Re: Zircaloy Clad  
Conversion  
ISAP Topic 2.17

Haddam Neck Plant  
Additional Information  
Small-Break Loss of Coolant Accident Analysis--  
Zircaloy Clad Fuel

Attachment  
Haddam Neck Plant  
Additional Information

**FIGURE 6-1**  
**HADDAM NECK PLANT ZIRCALOY SBLOCA**  
**0.01 FT2 DISCHARGE LEG BREAK**

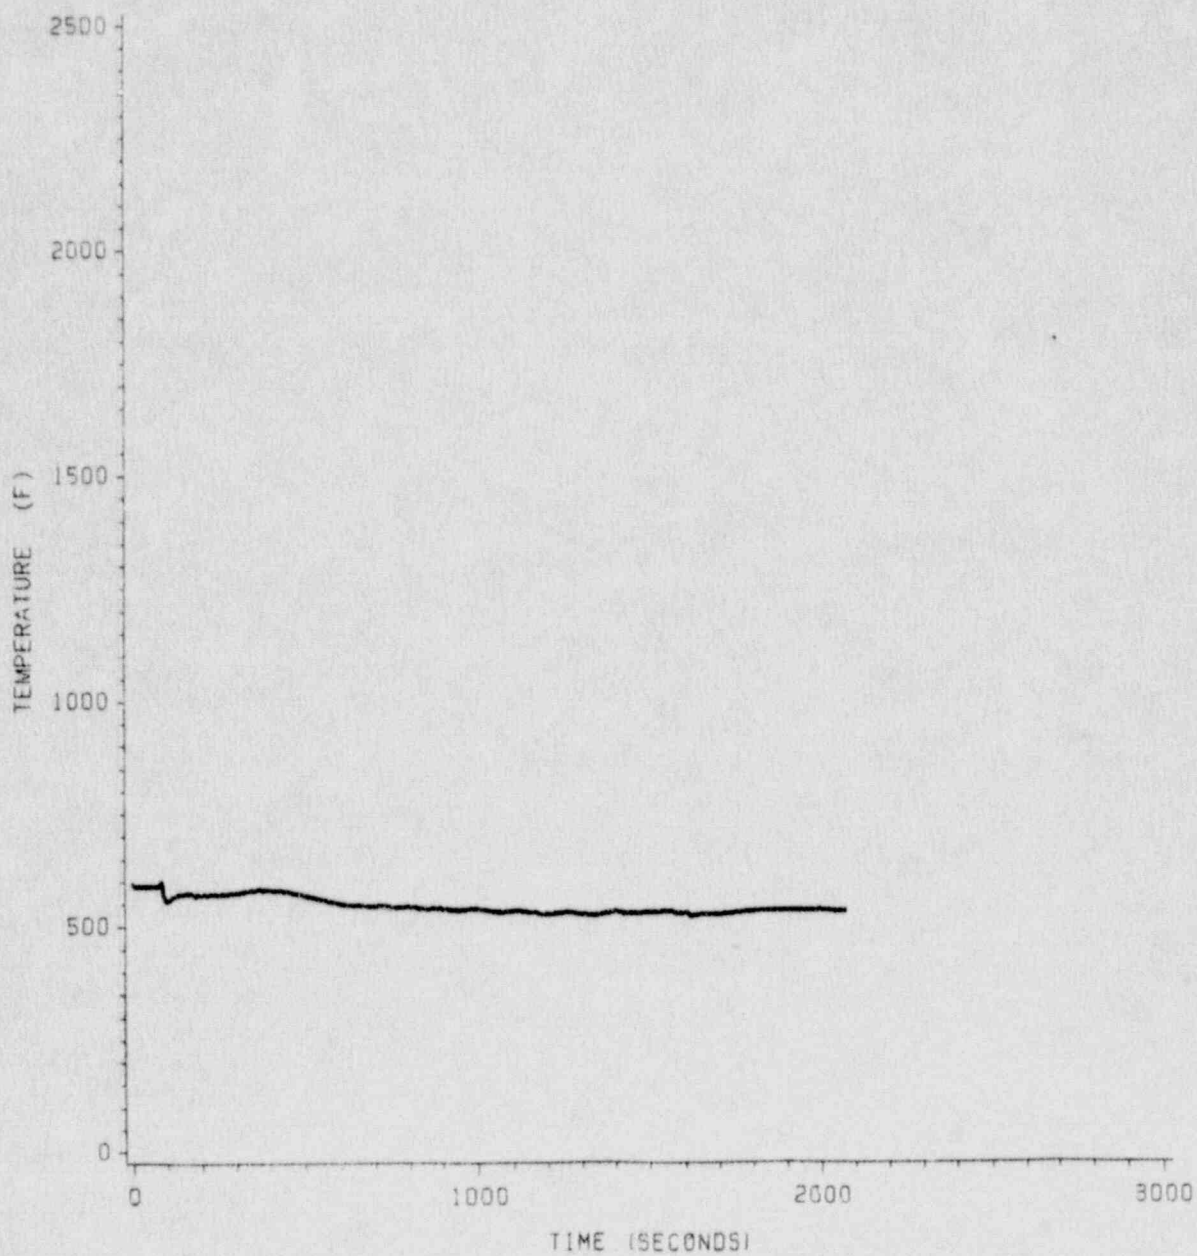
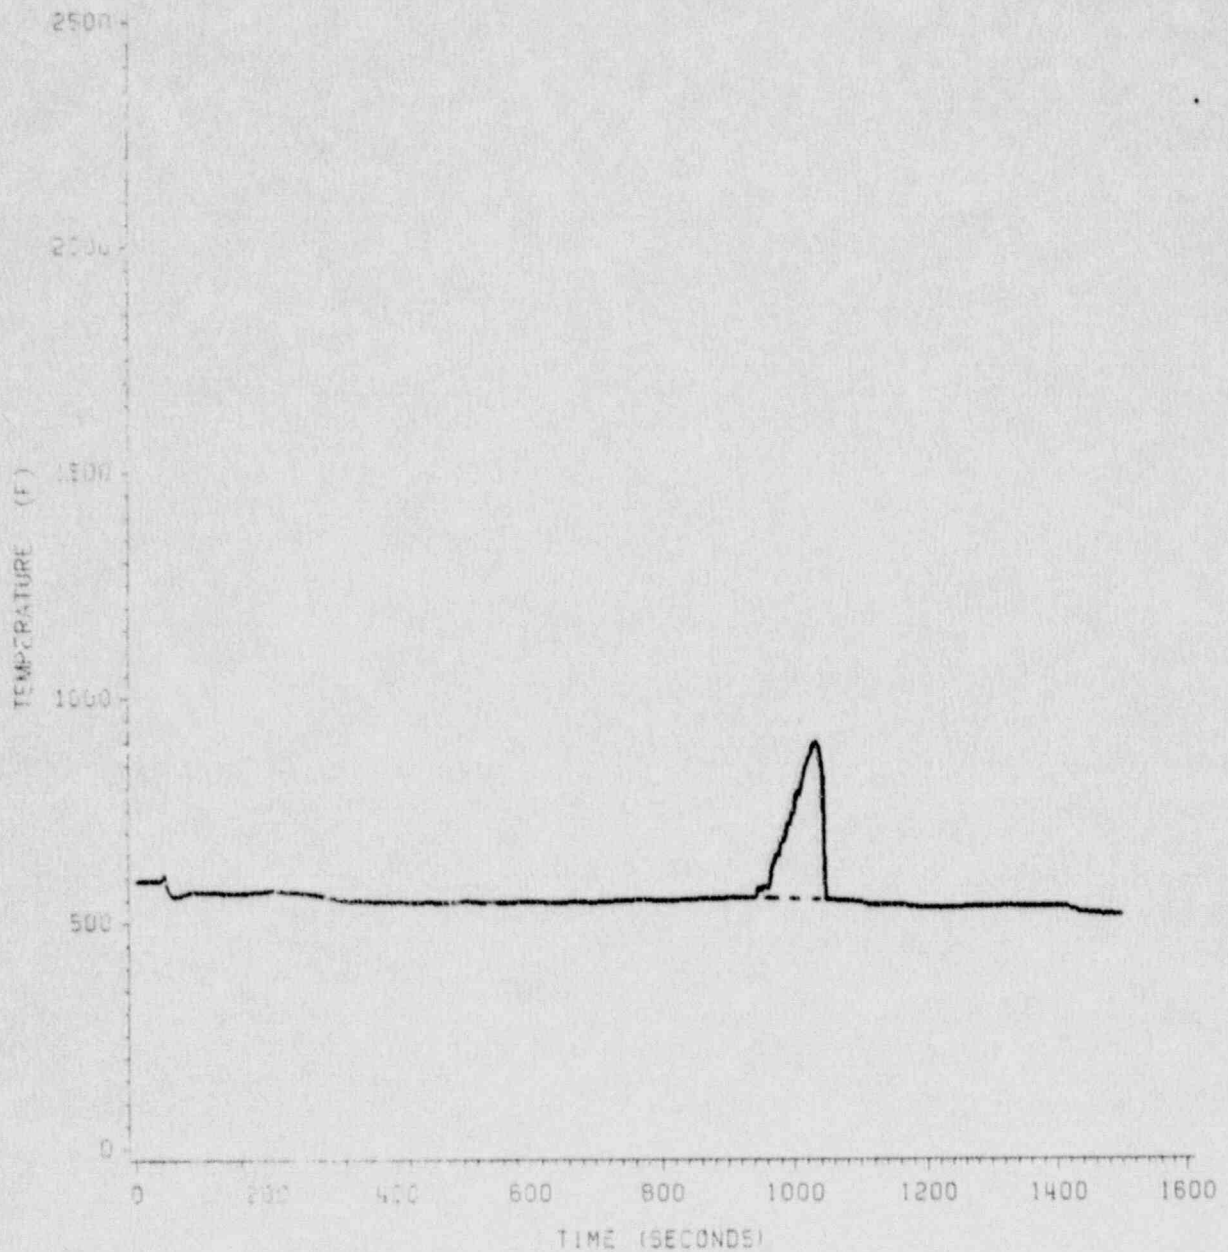
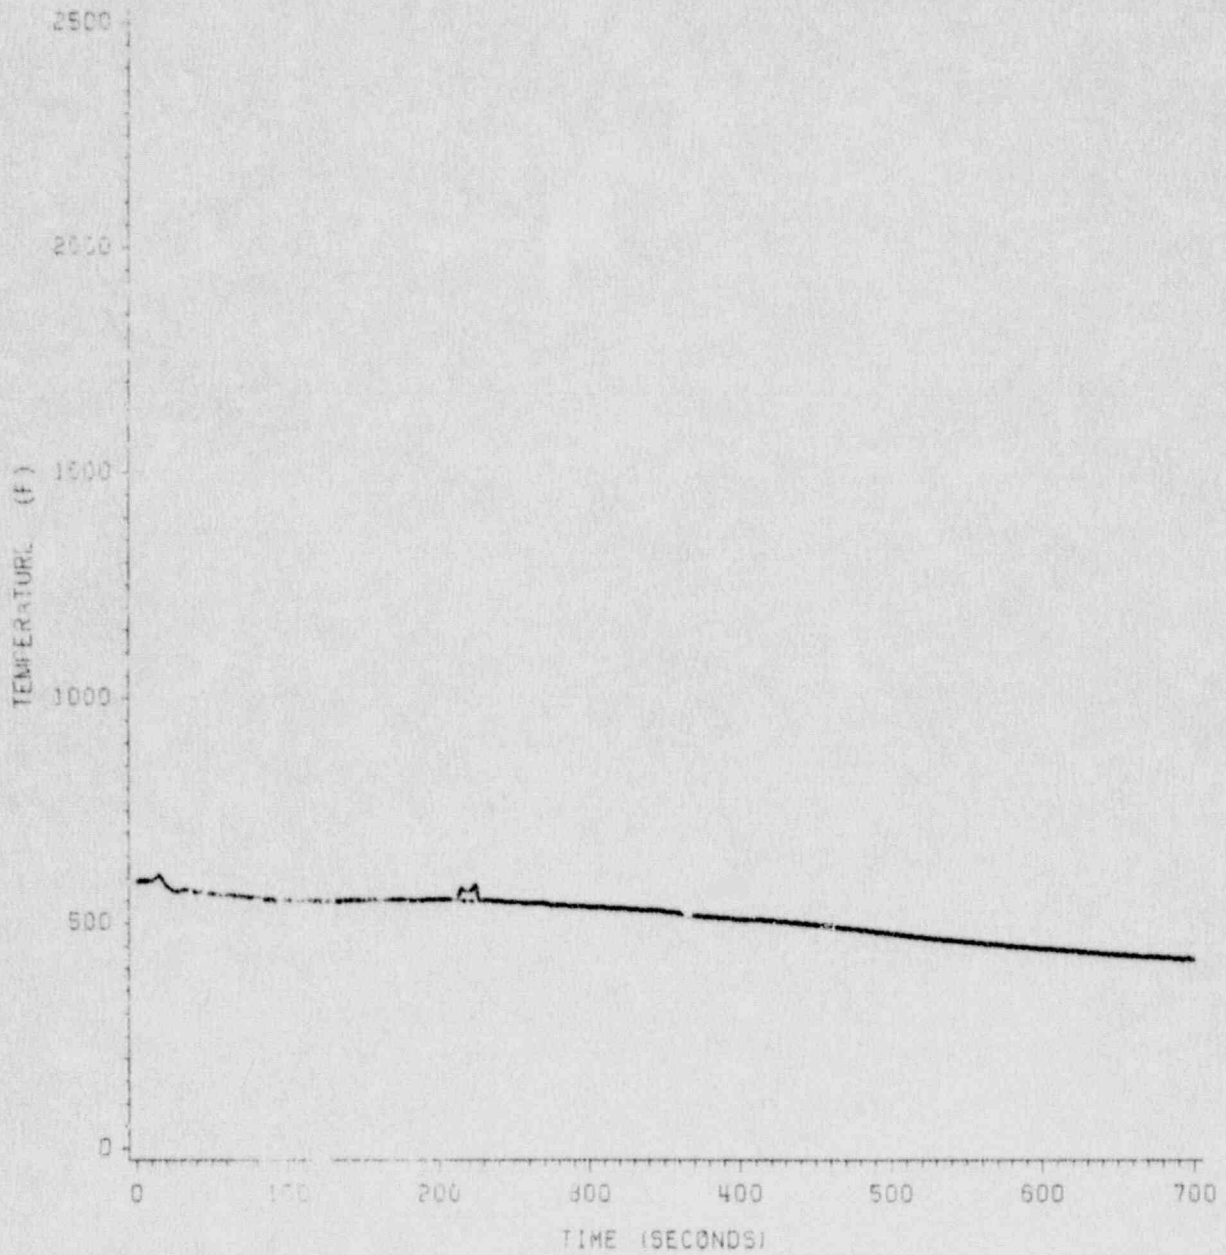
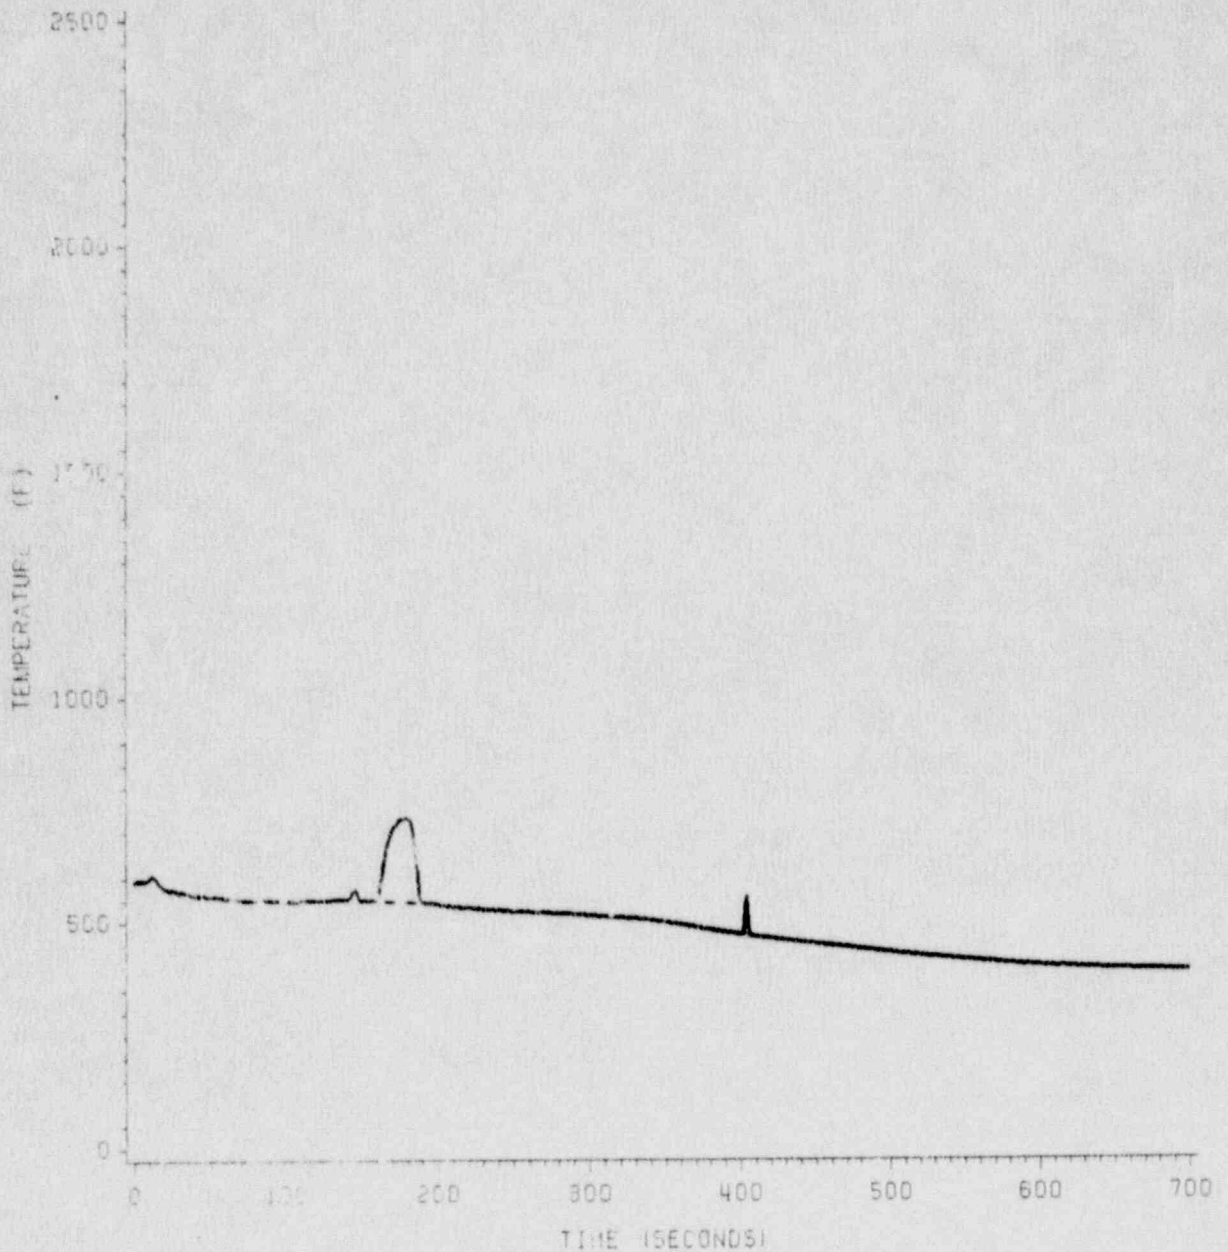
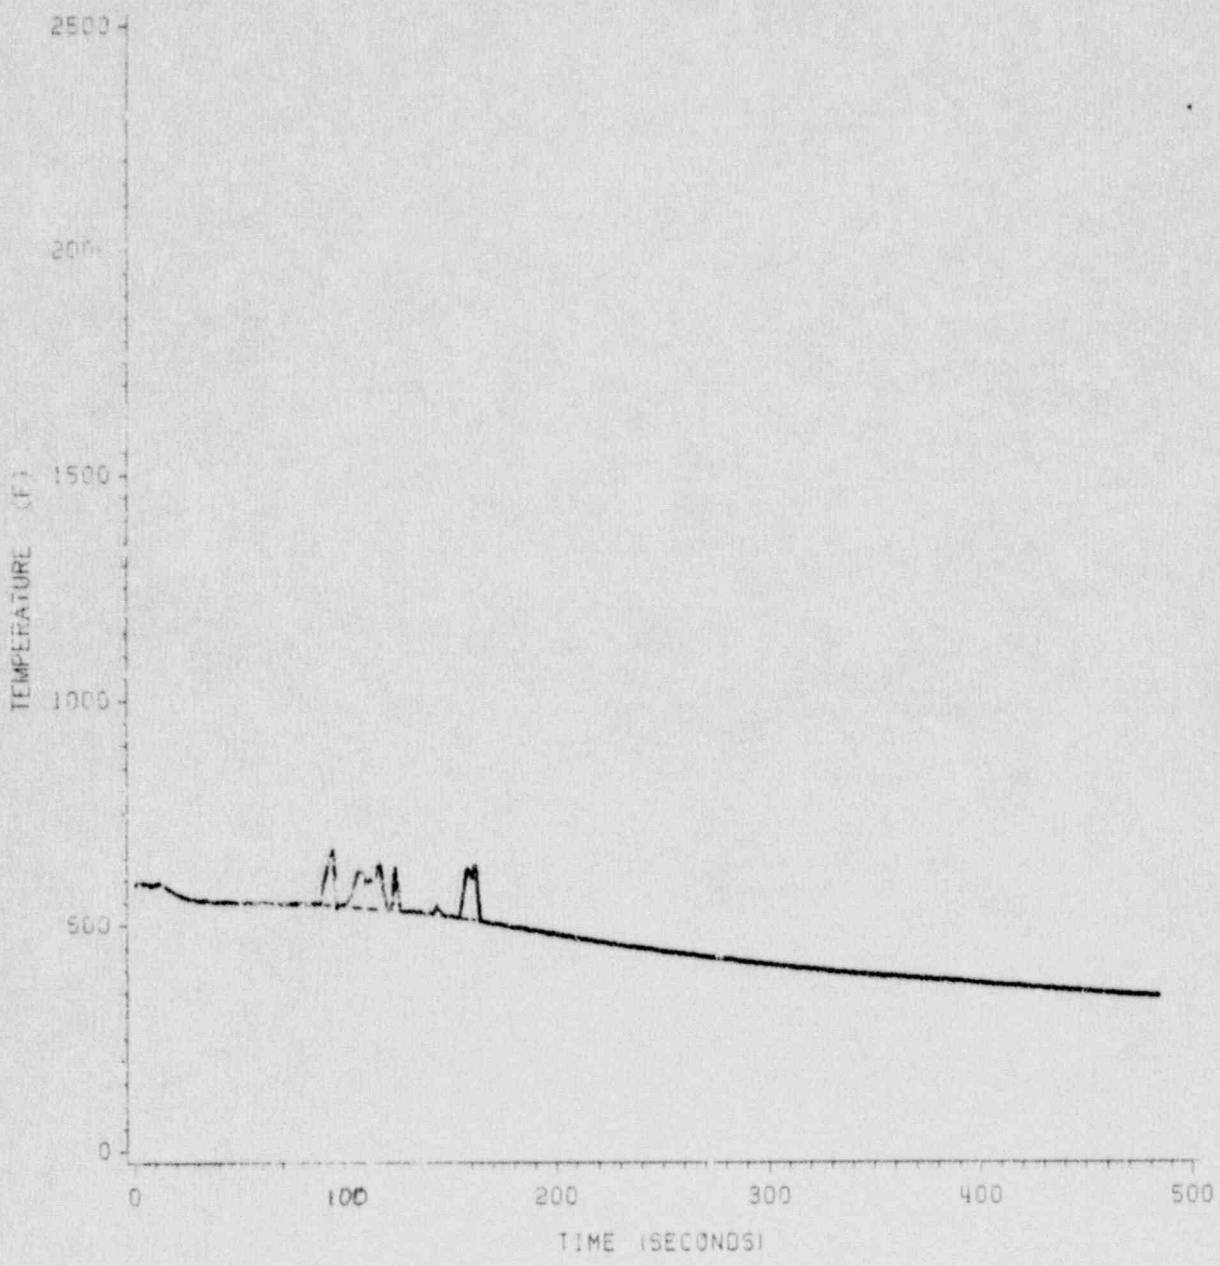
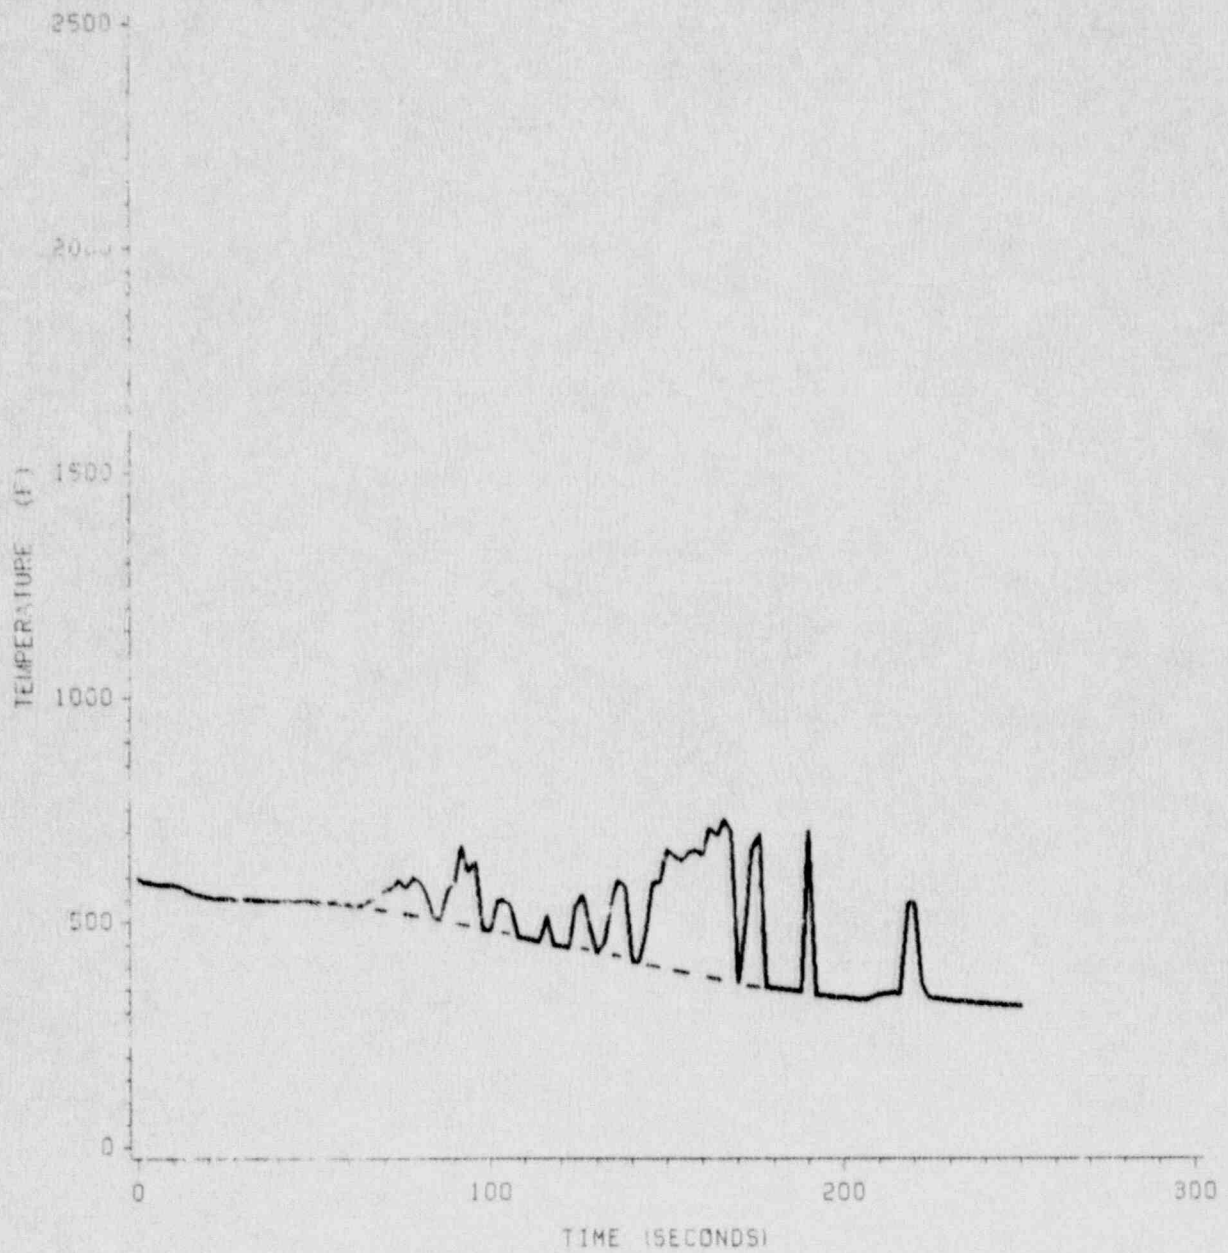
Please supply plots of the hot rod channel steam temperatures and saturation temperatures for each of the breaks.

Figures 6-1 through 6-6 provide the requested information.
